PRODUCT/PROCESS CHANGE NOTICE (PCN)

PCN #: L-0607-01R1 Product Affected: Please see the attached list of the affected products shipped in tape and reel, and in tubes Date Effective: 6-Oct-06	DATE: 6-Oct-06	MEANS OF DISTINGUISHING CHANGED DEVICES: <input type="checkbox"/> Product Mark <input type="checkbox"/> Back Mark <input checked="" type="checkbox"/> Date Code <input type="checkbox"/> Other Lot shipments will have Level 1 Moisture Sensitive Label, and with date code starting "0630".
---	-----------------------	---

PCN Type: Change in Moisture Sensitivity Level

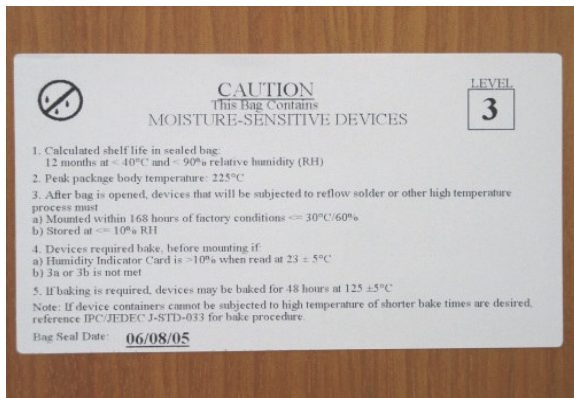
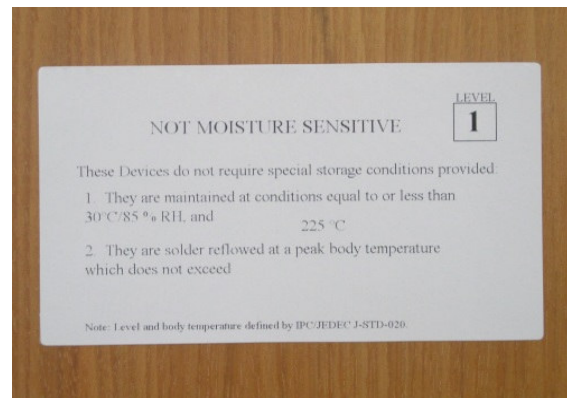
This notification is to advise customers that IDT is converting ICS MSL 3 products shipped in tape and reel, and in tubes, to MSL 1. IDT has completed the verification of the moisture sensitivity classification of ICS products to MSL 1.

The affected products will be shipped without dry pack and labelled as MSL 1 according the JEDEC J-STD-033. There is no change to the assembly material set and the peak reflow temperature. Please refer below for the examples of moisture sensitive labels.

From: MSL 3 Moisture Sensitive Label

To: MSL 1 Non-Moisture Label

Note: There is no change to the peak reflow temperature of the affected products.
